**Report of the Transportation Advisory Committee
to the
Arlington Board of Selectmen**

5 January 2006

**Appleton Street, Paul Revere Road and
Florence Avenue Intersection**

Figure 1 Traffic Turning Counts for Weekday Evening Peak Hour
(Conducted 9/27/05, 5:30 - 6:30 PM)

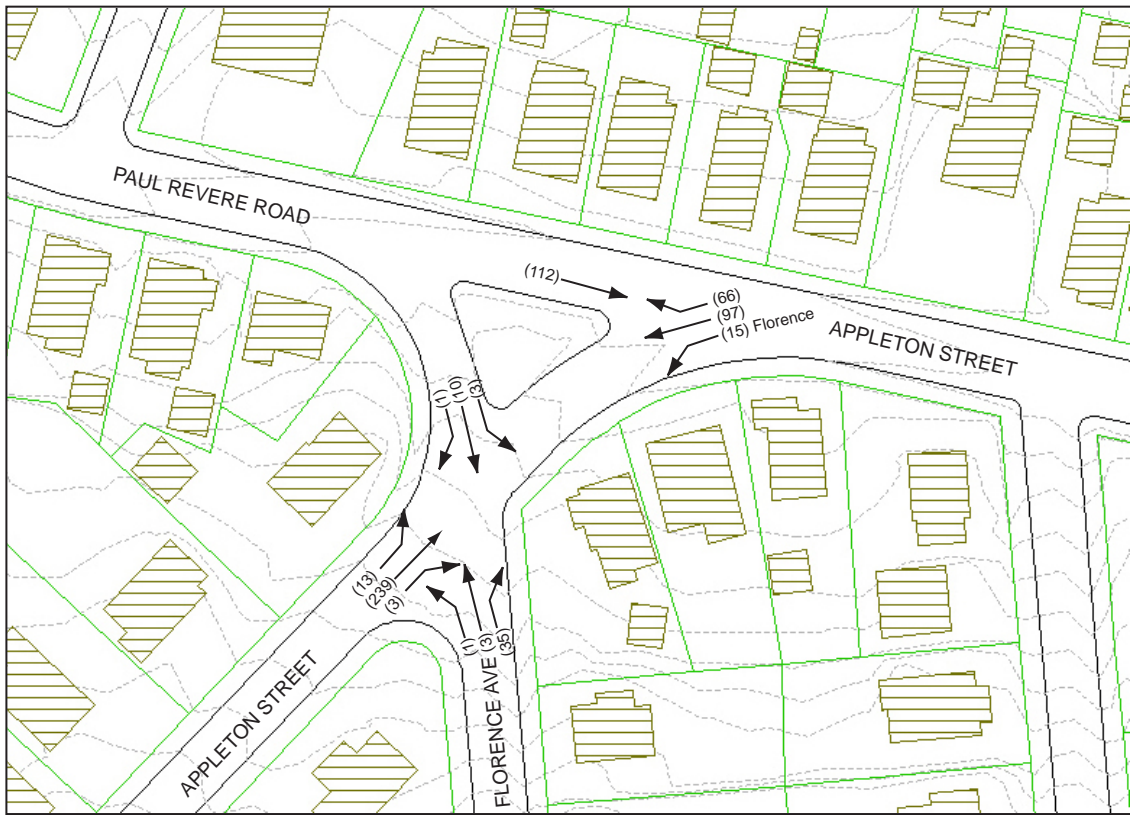
Traffic counts indicate that the highest volume on this section of Appleton Street occurs during the PM peak. Turning counts were conducted for the intersection during this time period (see Figure 1). The counts indicate that the primary traffic movement is eastbound on Appleton Street, although Appleton Street westbound and both directions on Paul Revere Road are also significant.

Figure 5 Recommendations for Appleton, Paul Revere and Florence Intersection

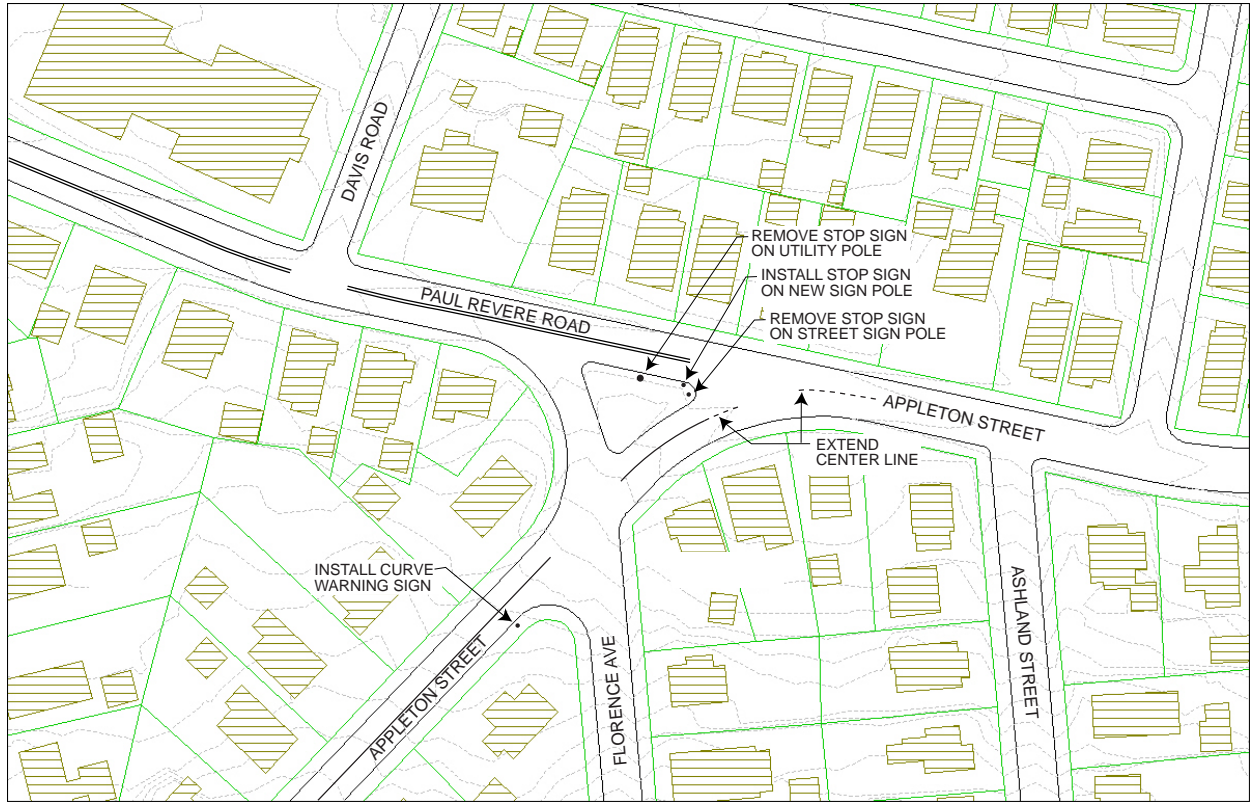
The following recommendations were voted unanimously at the TAC's December 13, 2005 meeting (see Figures 5 & 6):

1. Relocate the stop sign on the Paul Revere Road approach to Appleton Street to a more visible location.
2. Continue the yellow center line on Appleton Street through the curve.
3. Install a curve warning sign (MUTCD W1-2R, or similar) on Appleton Street on the eastbound approach to this intersection.
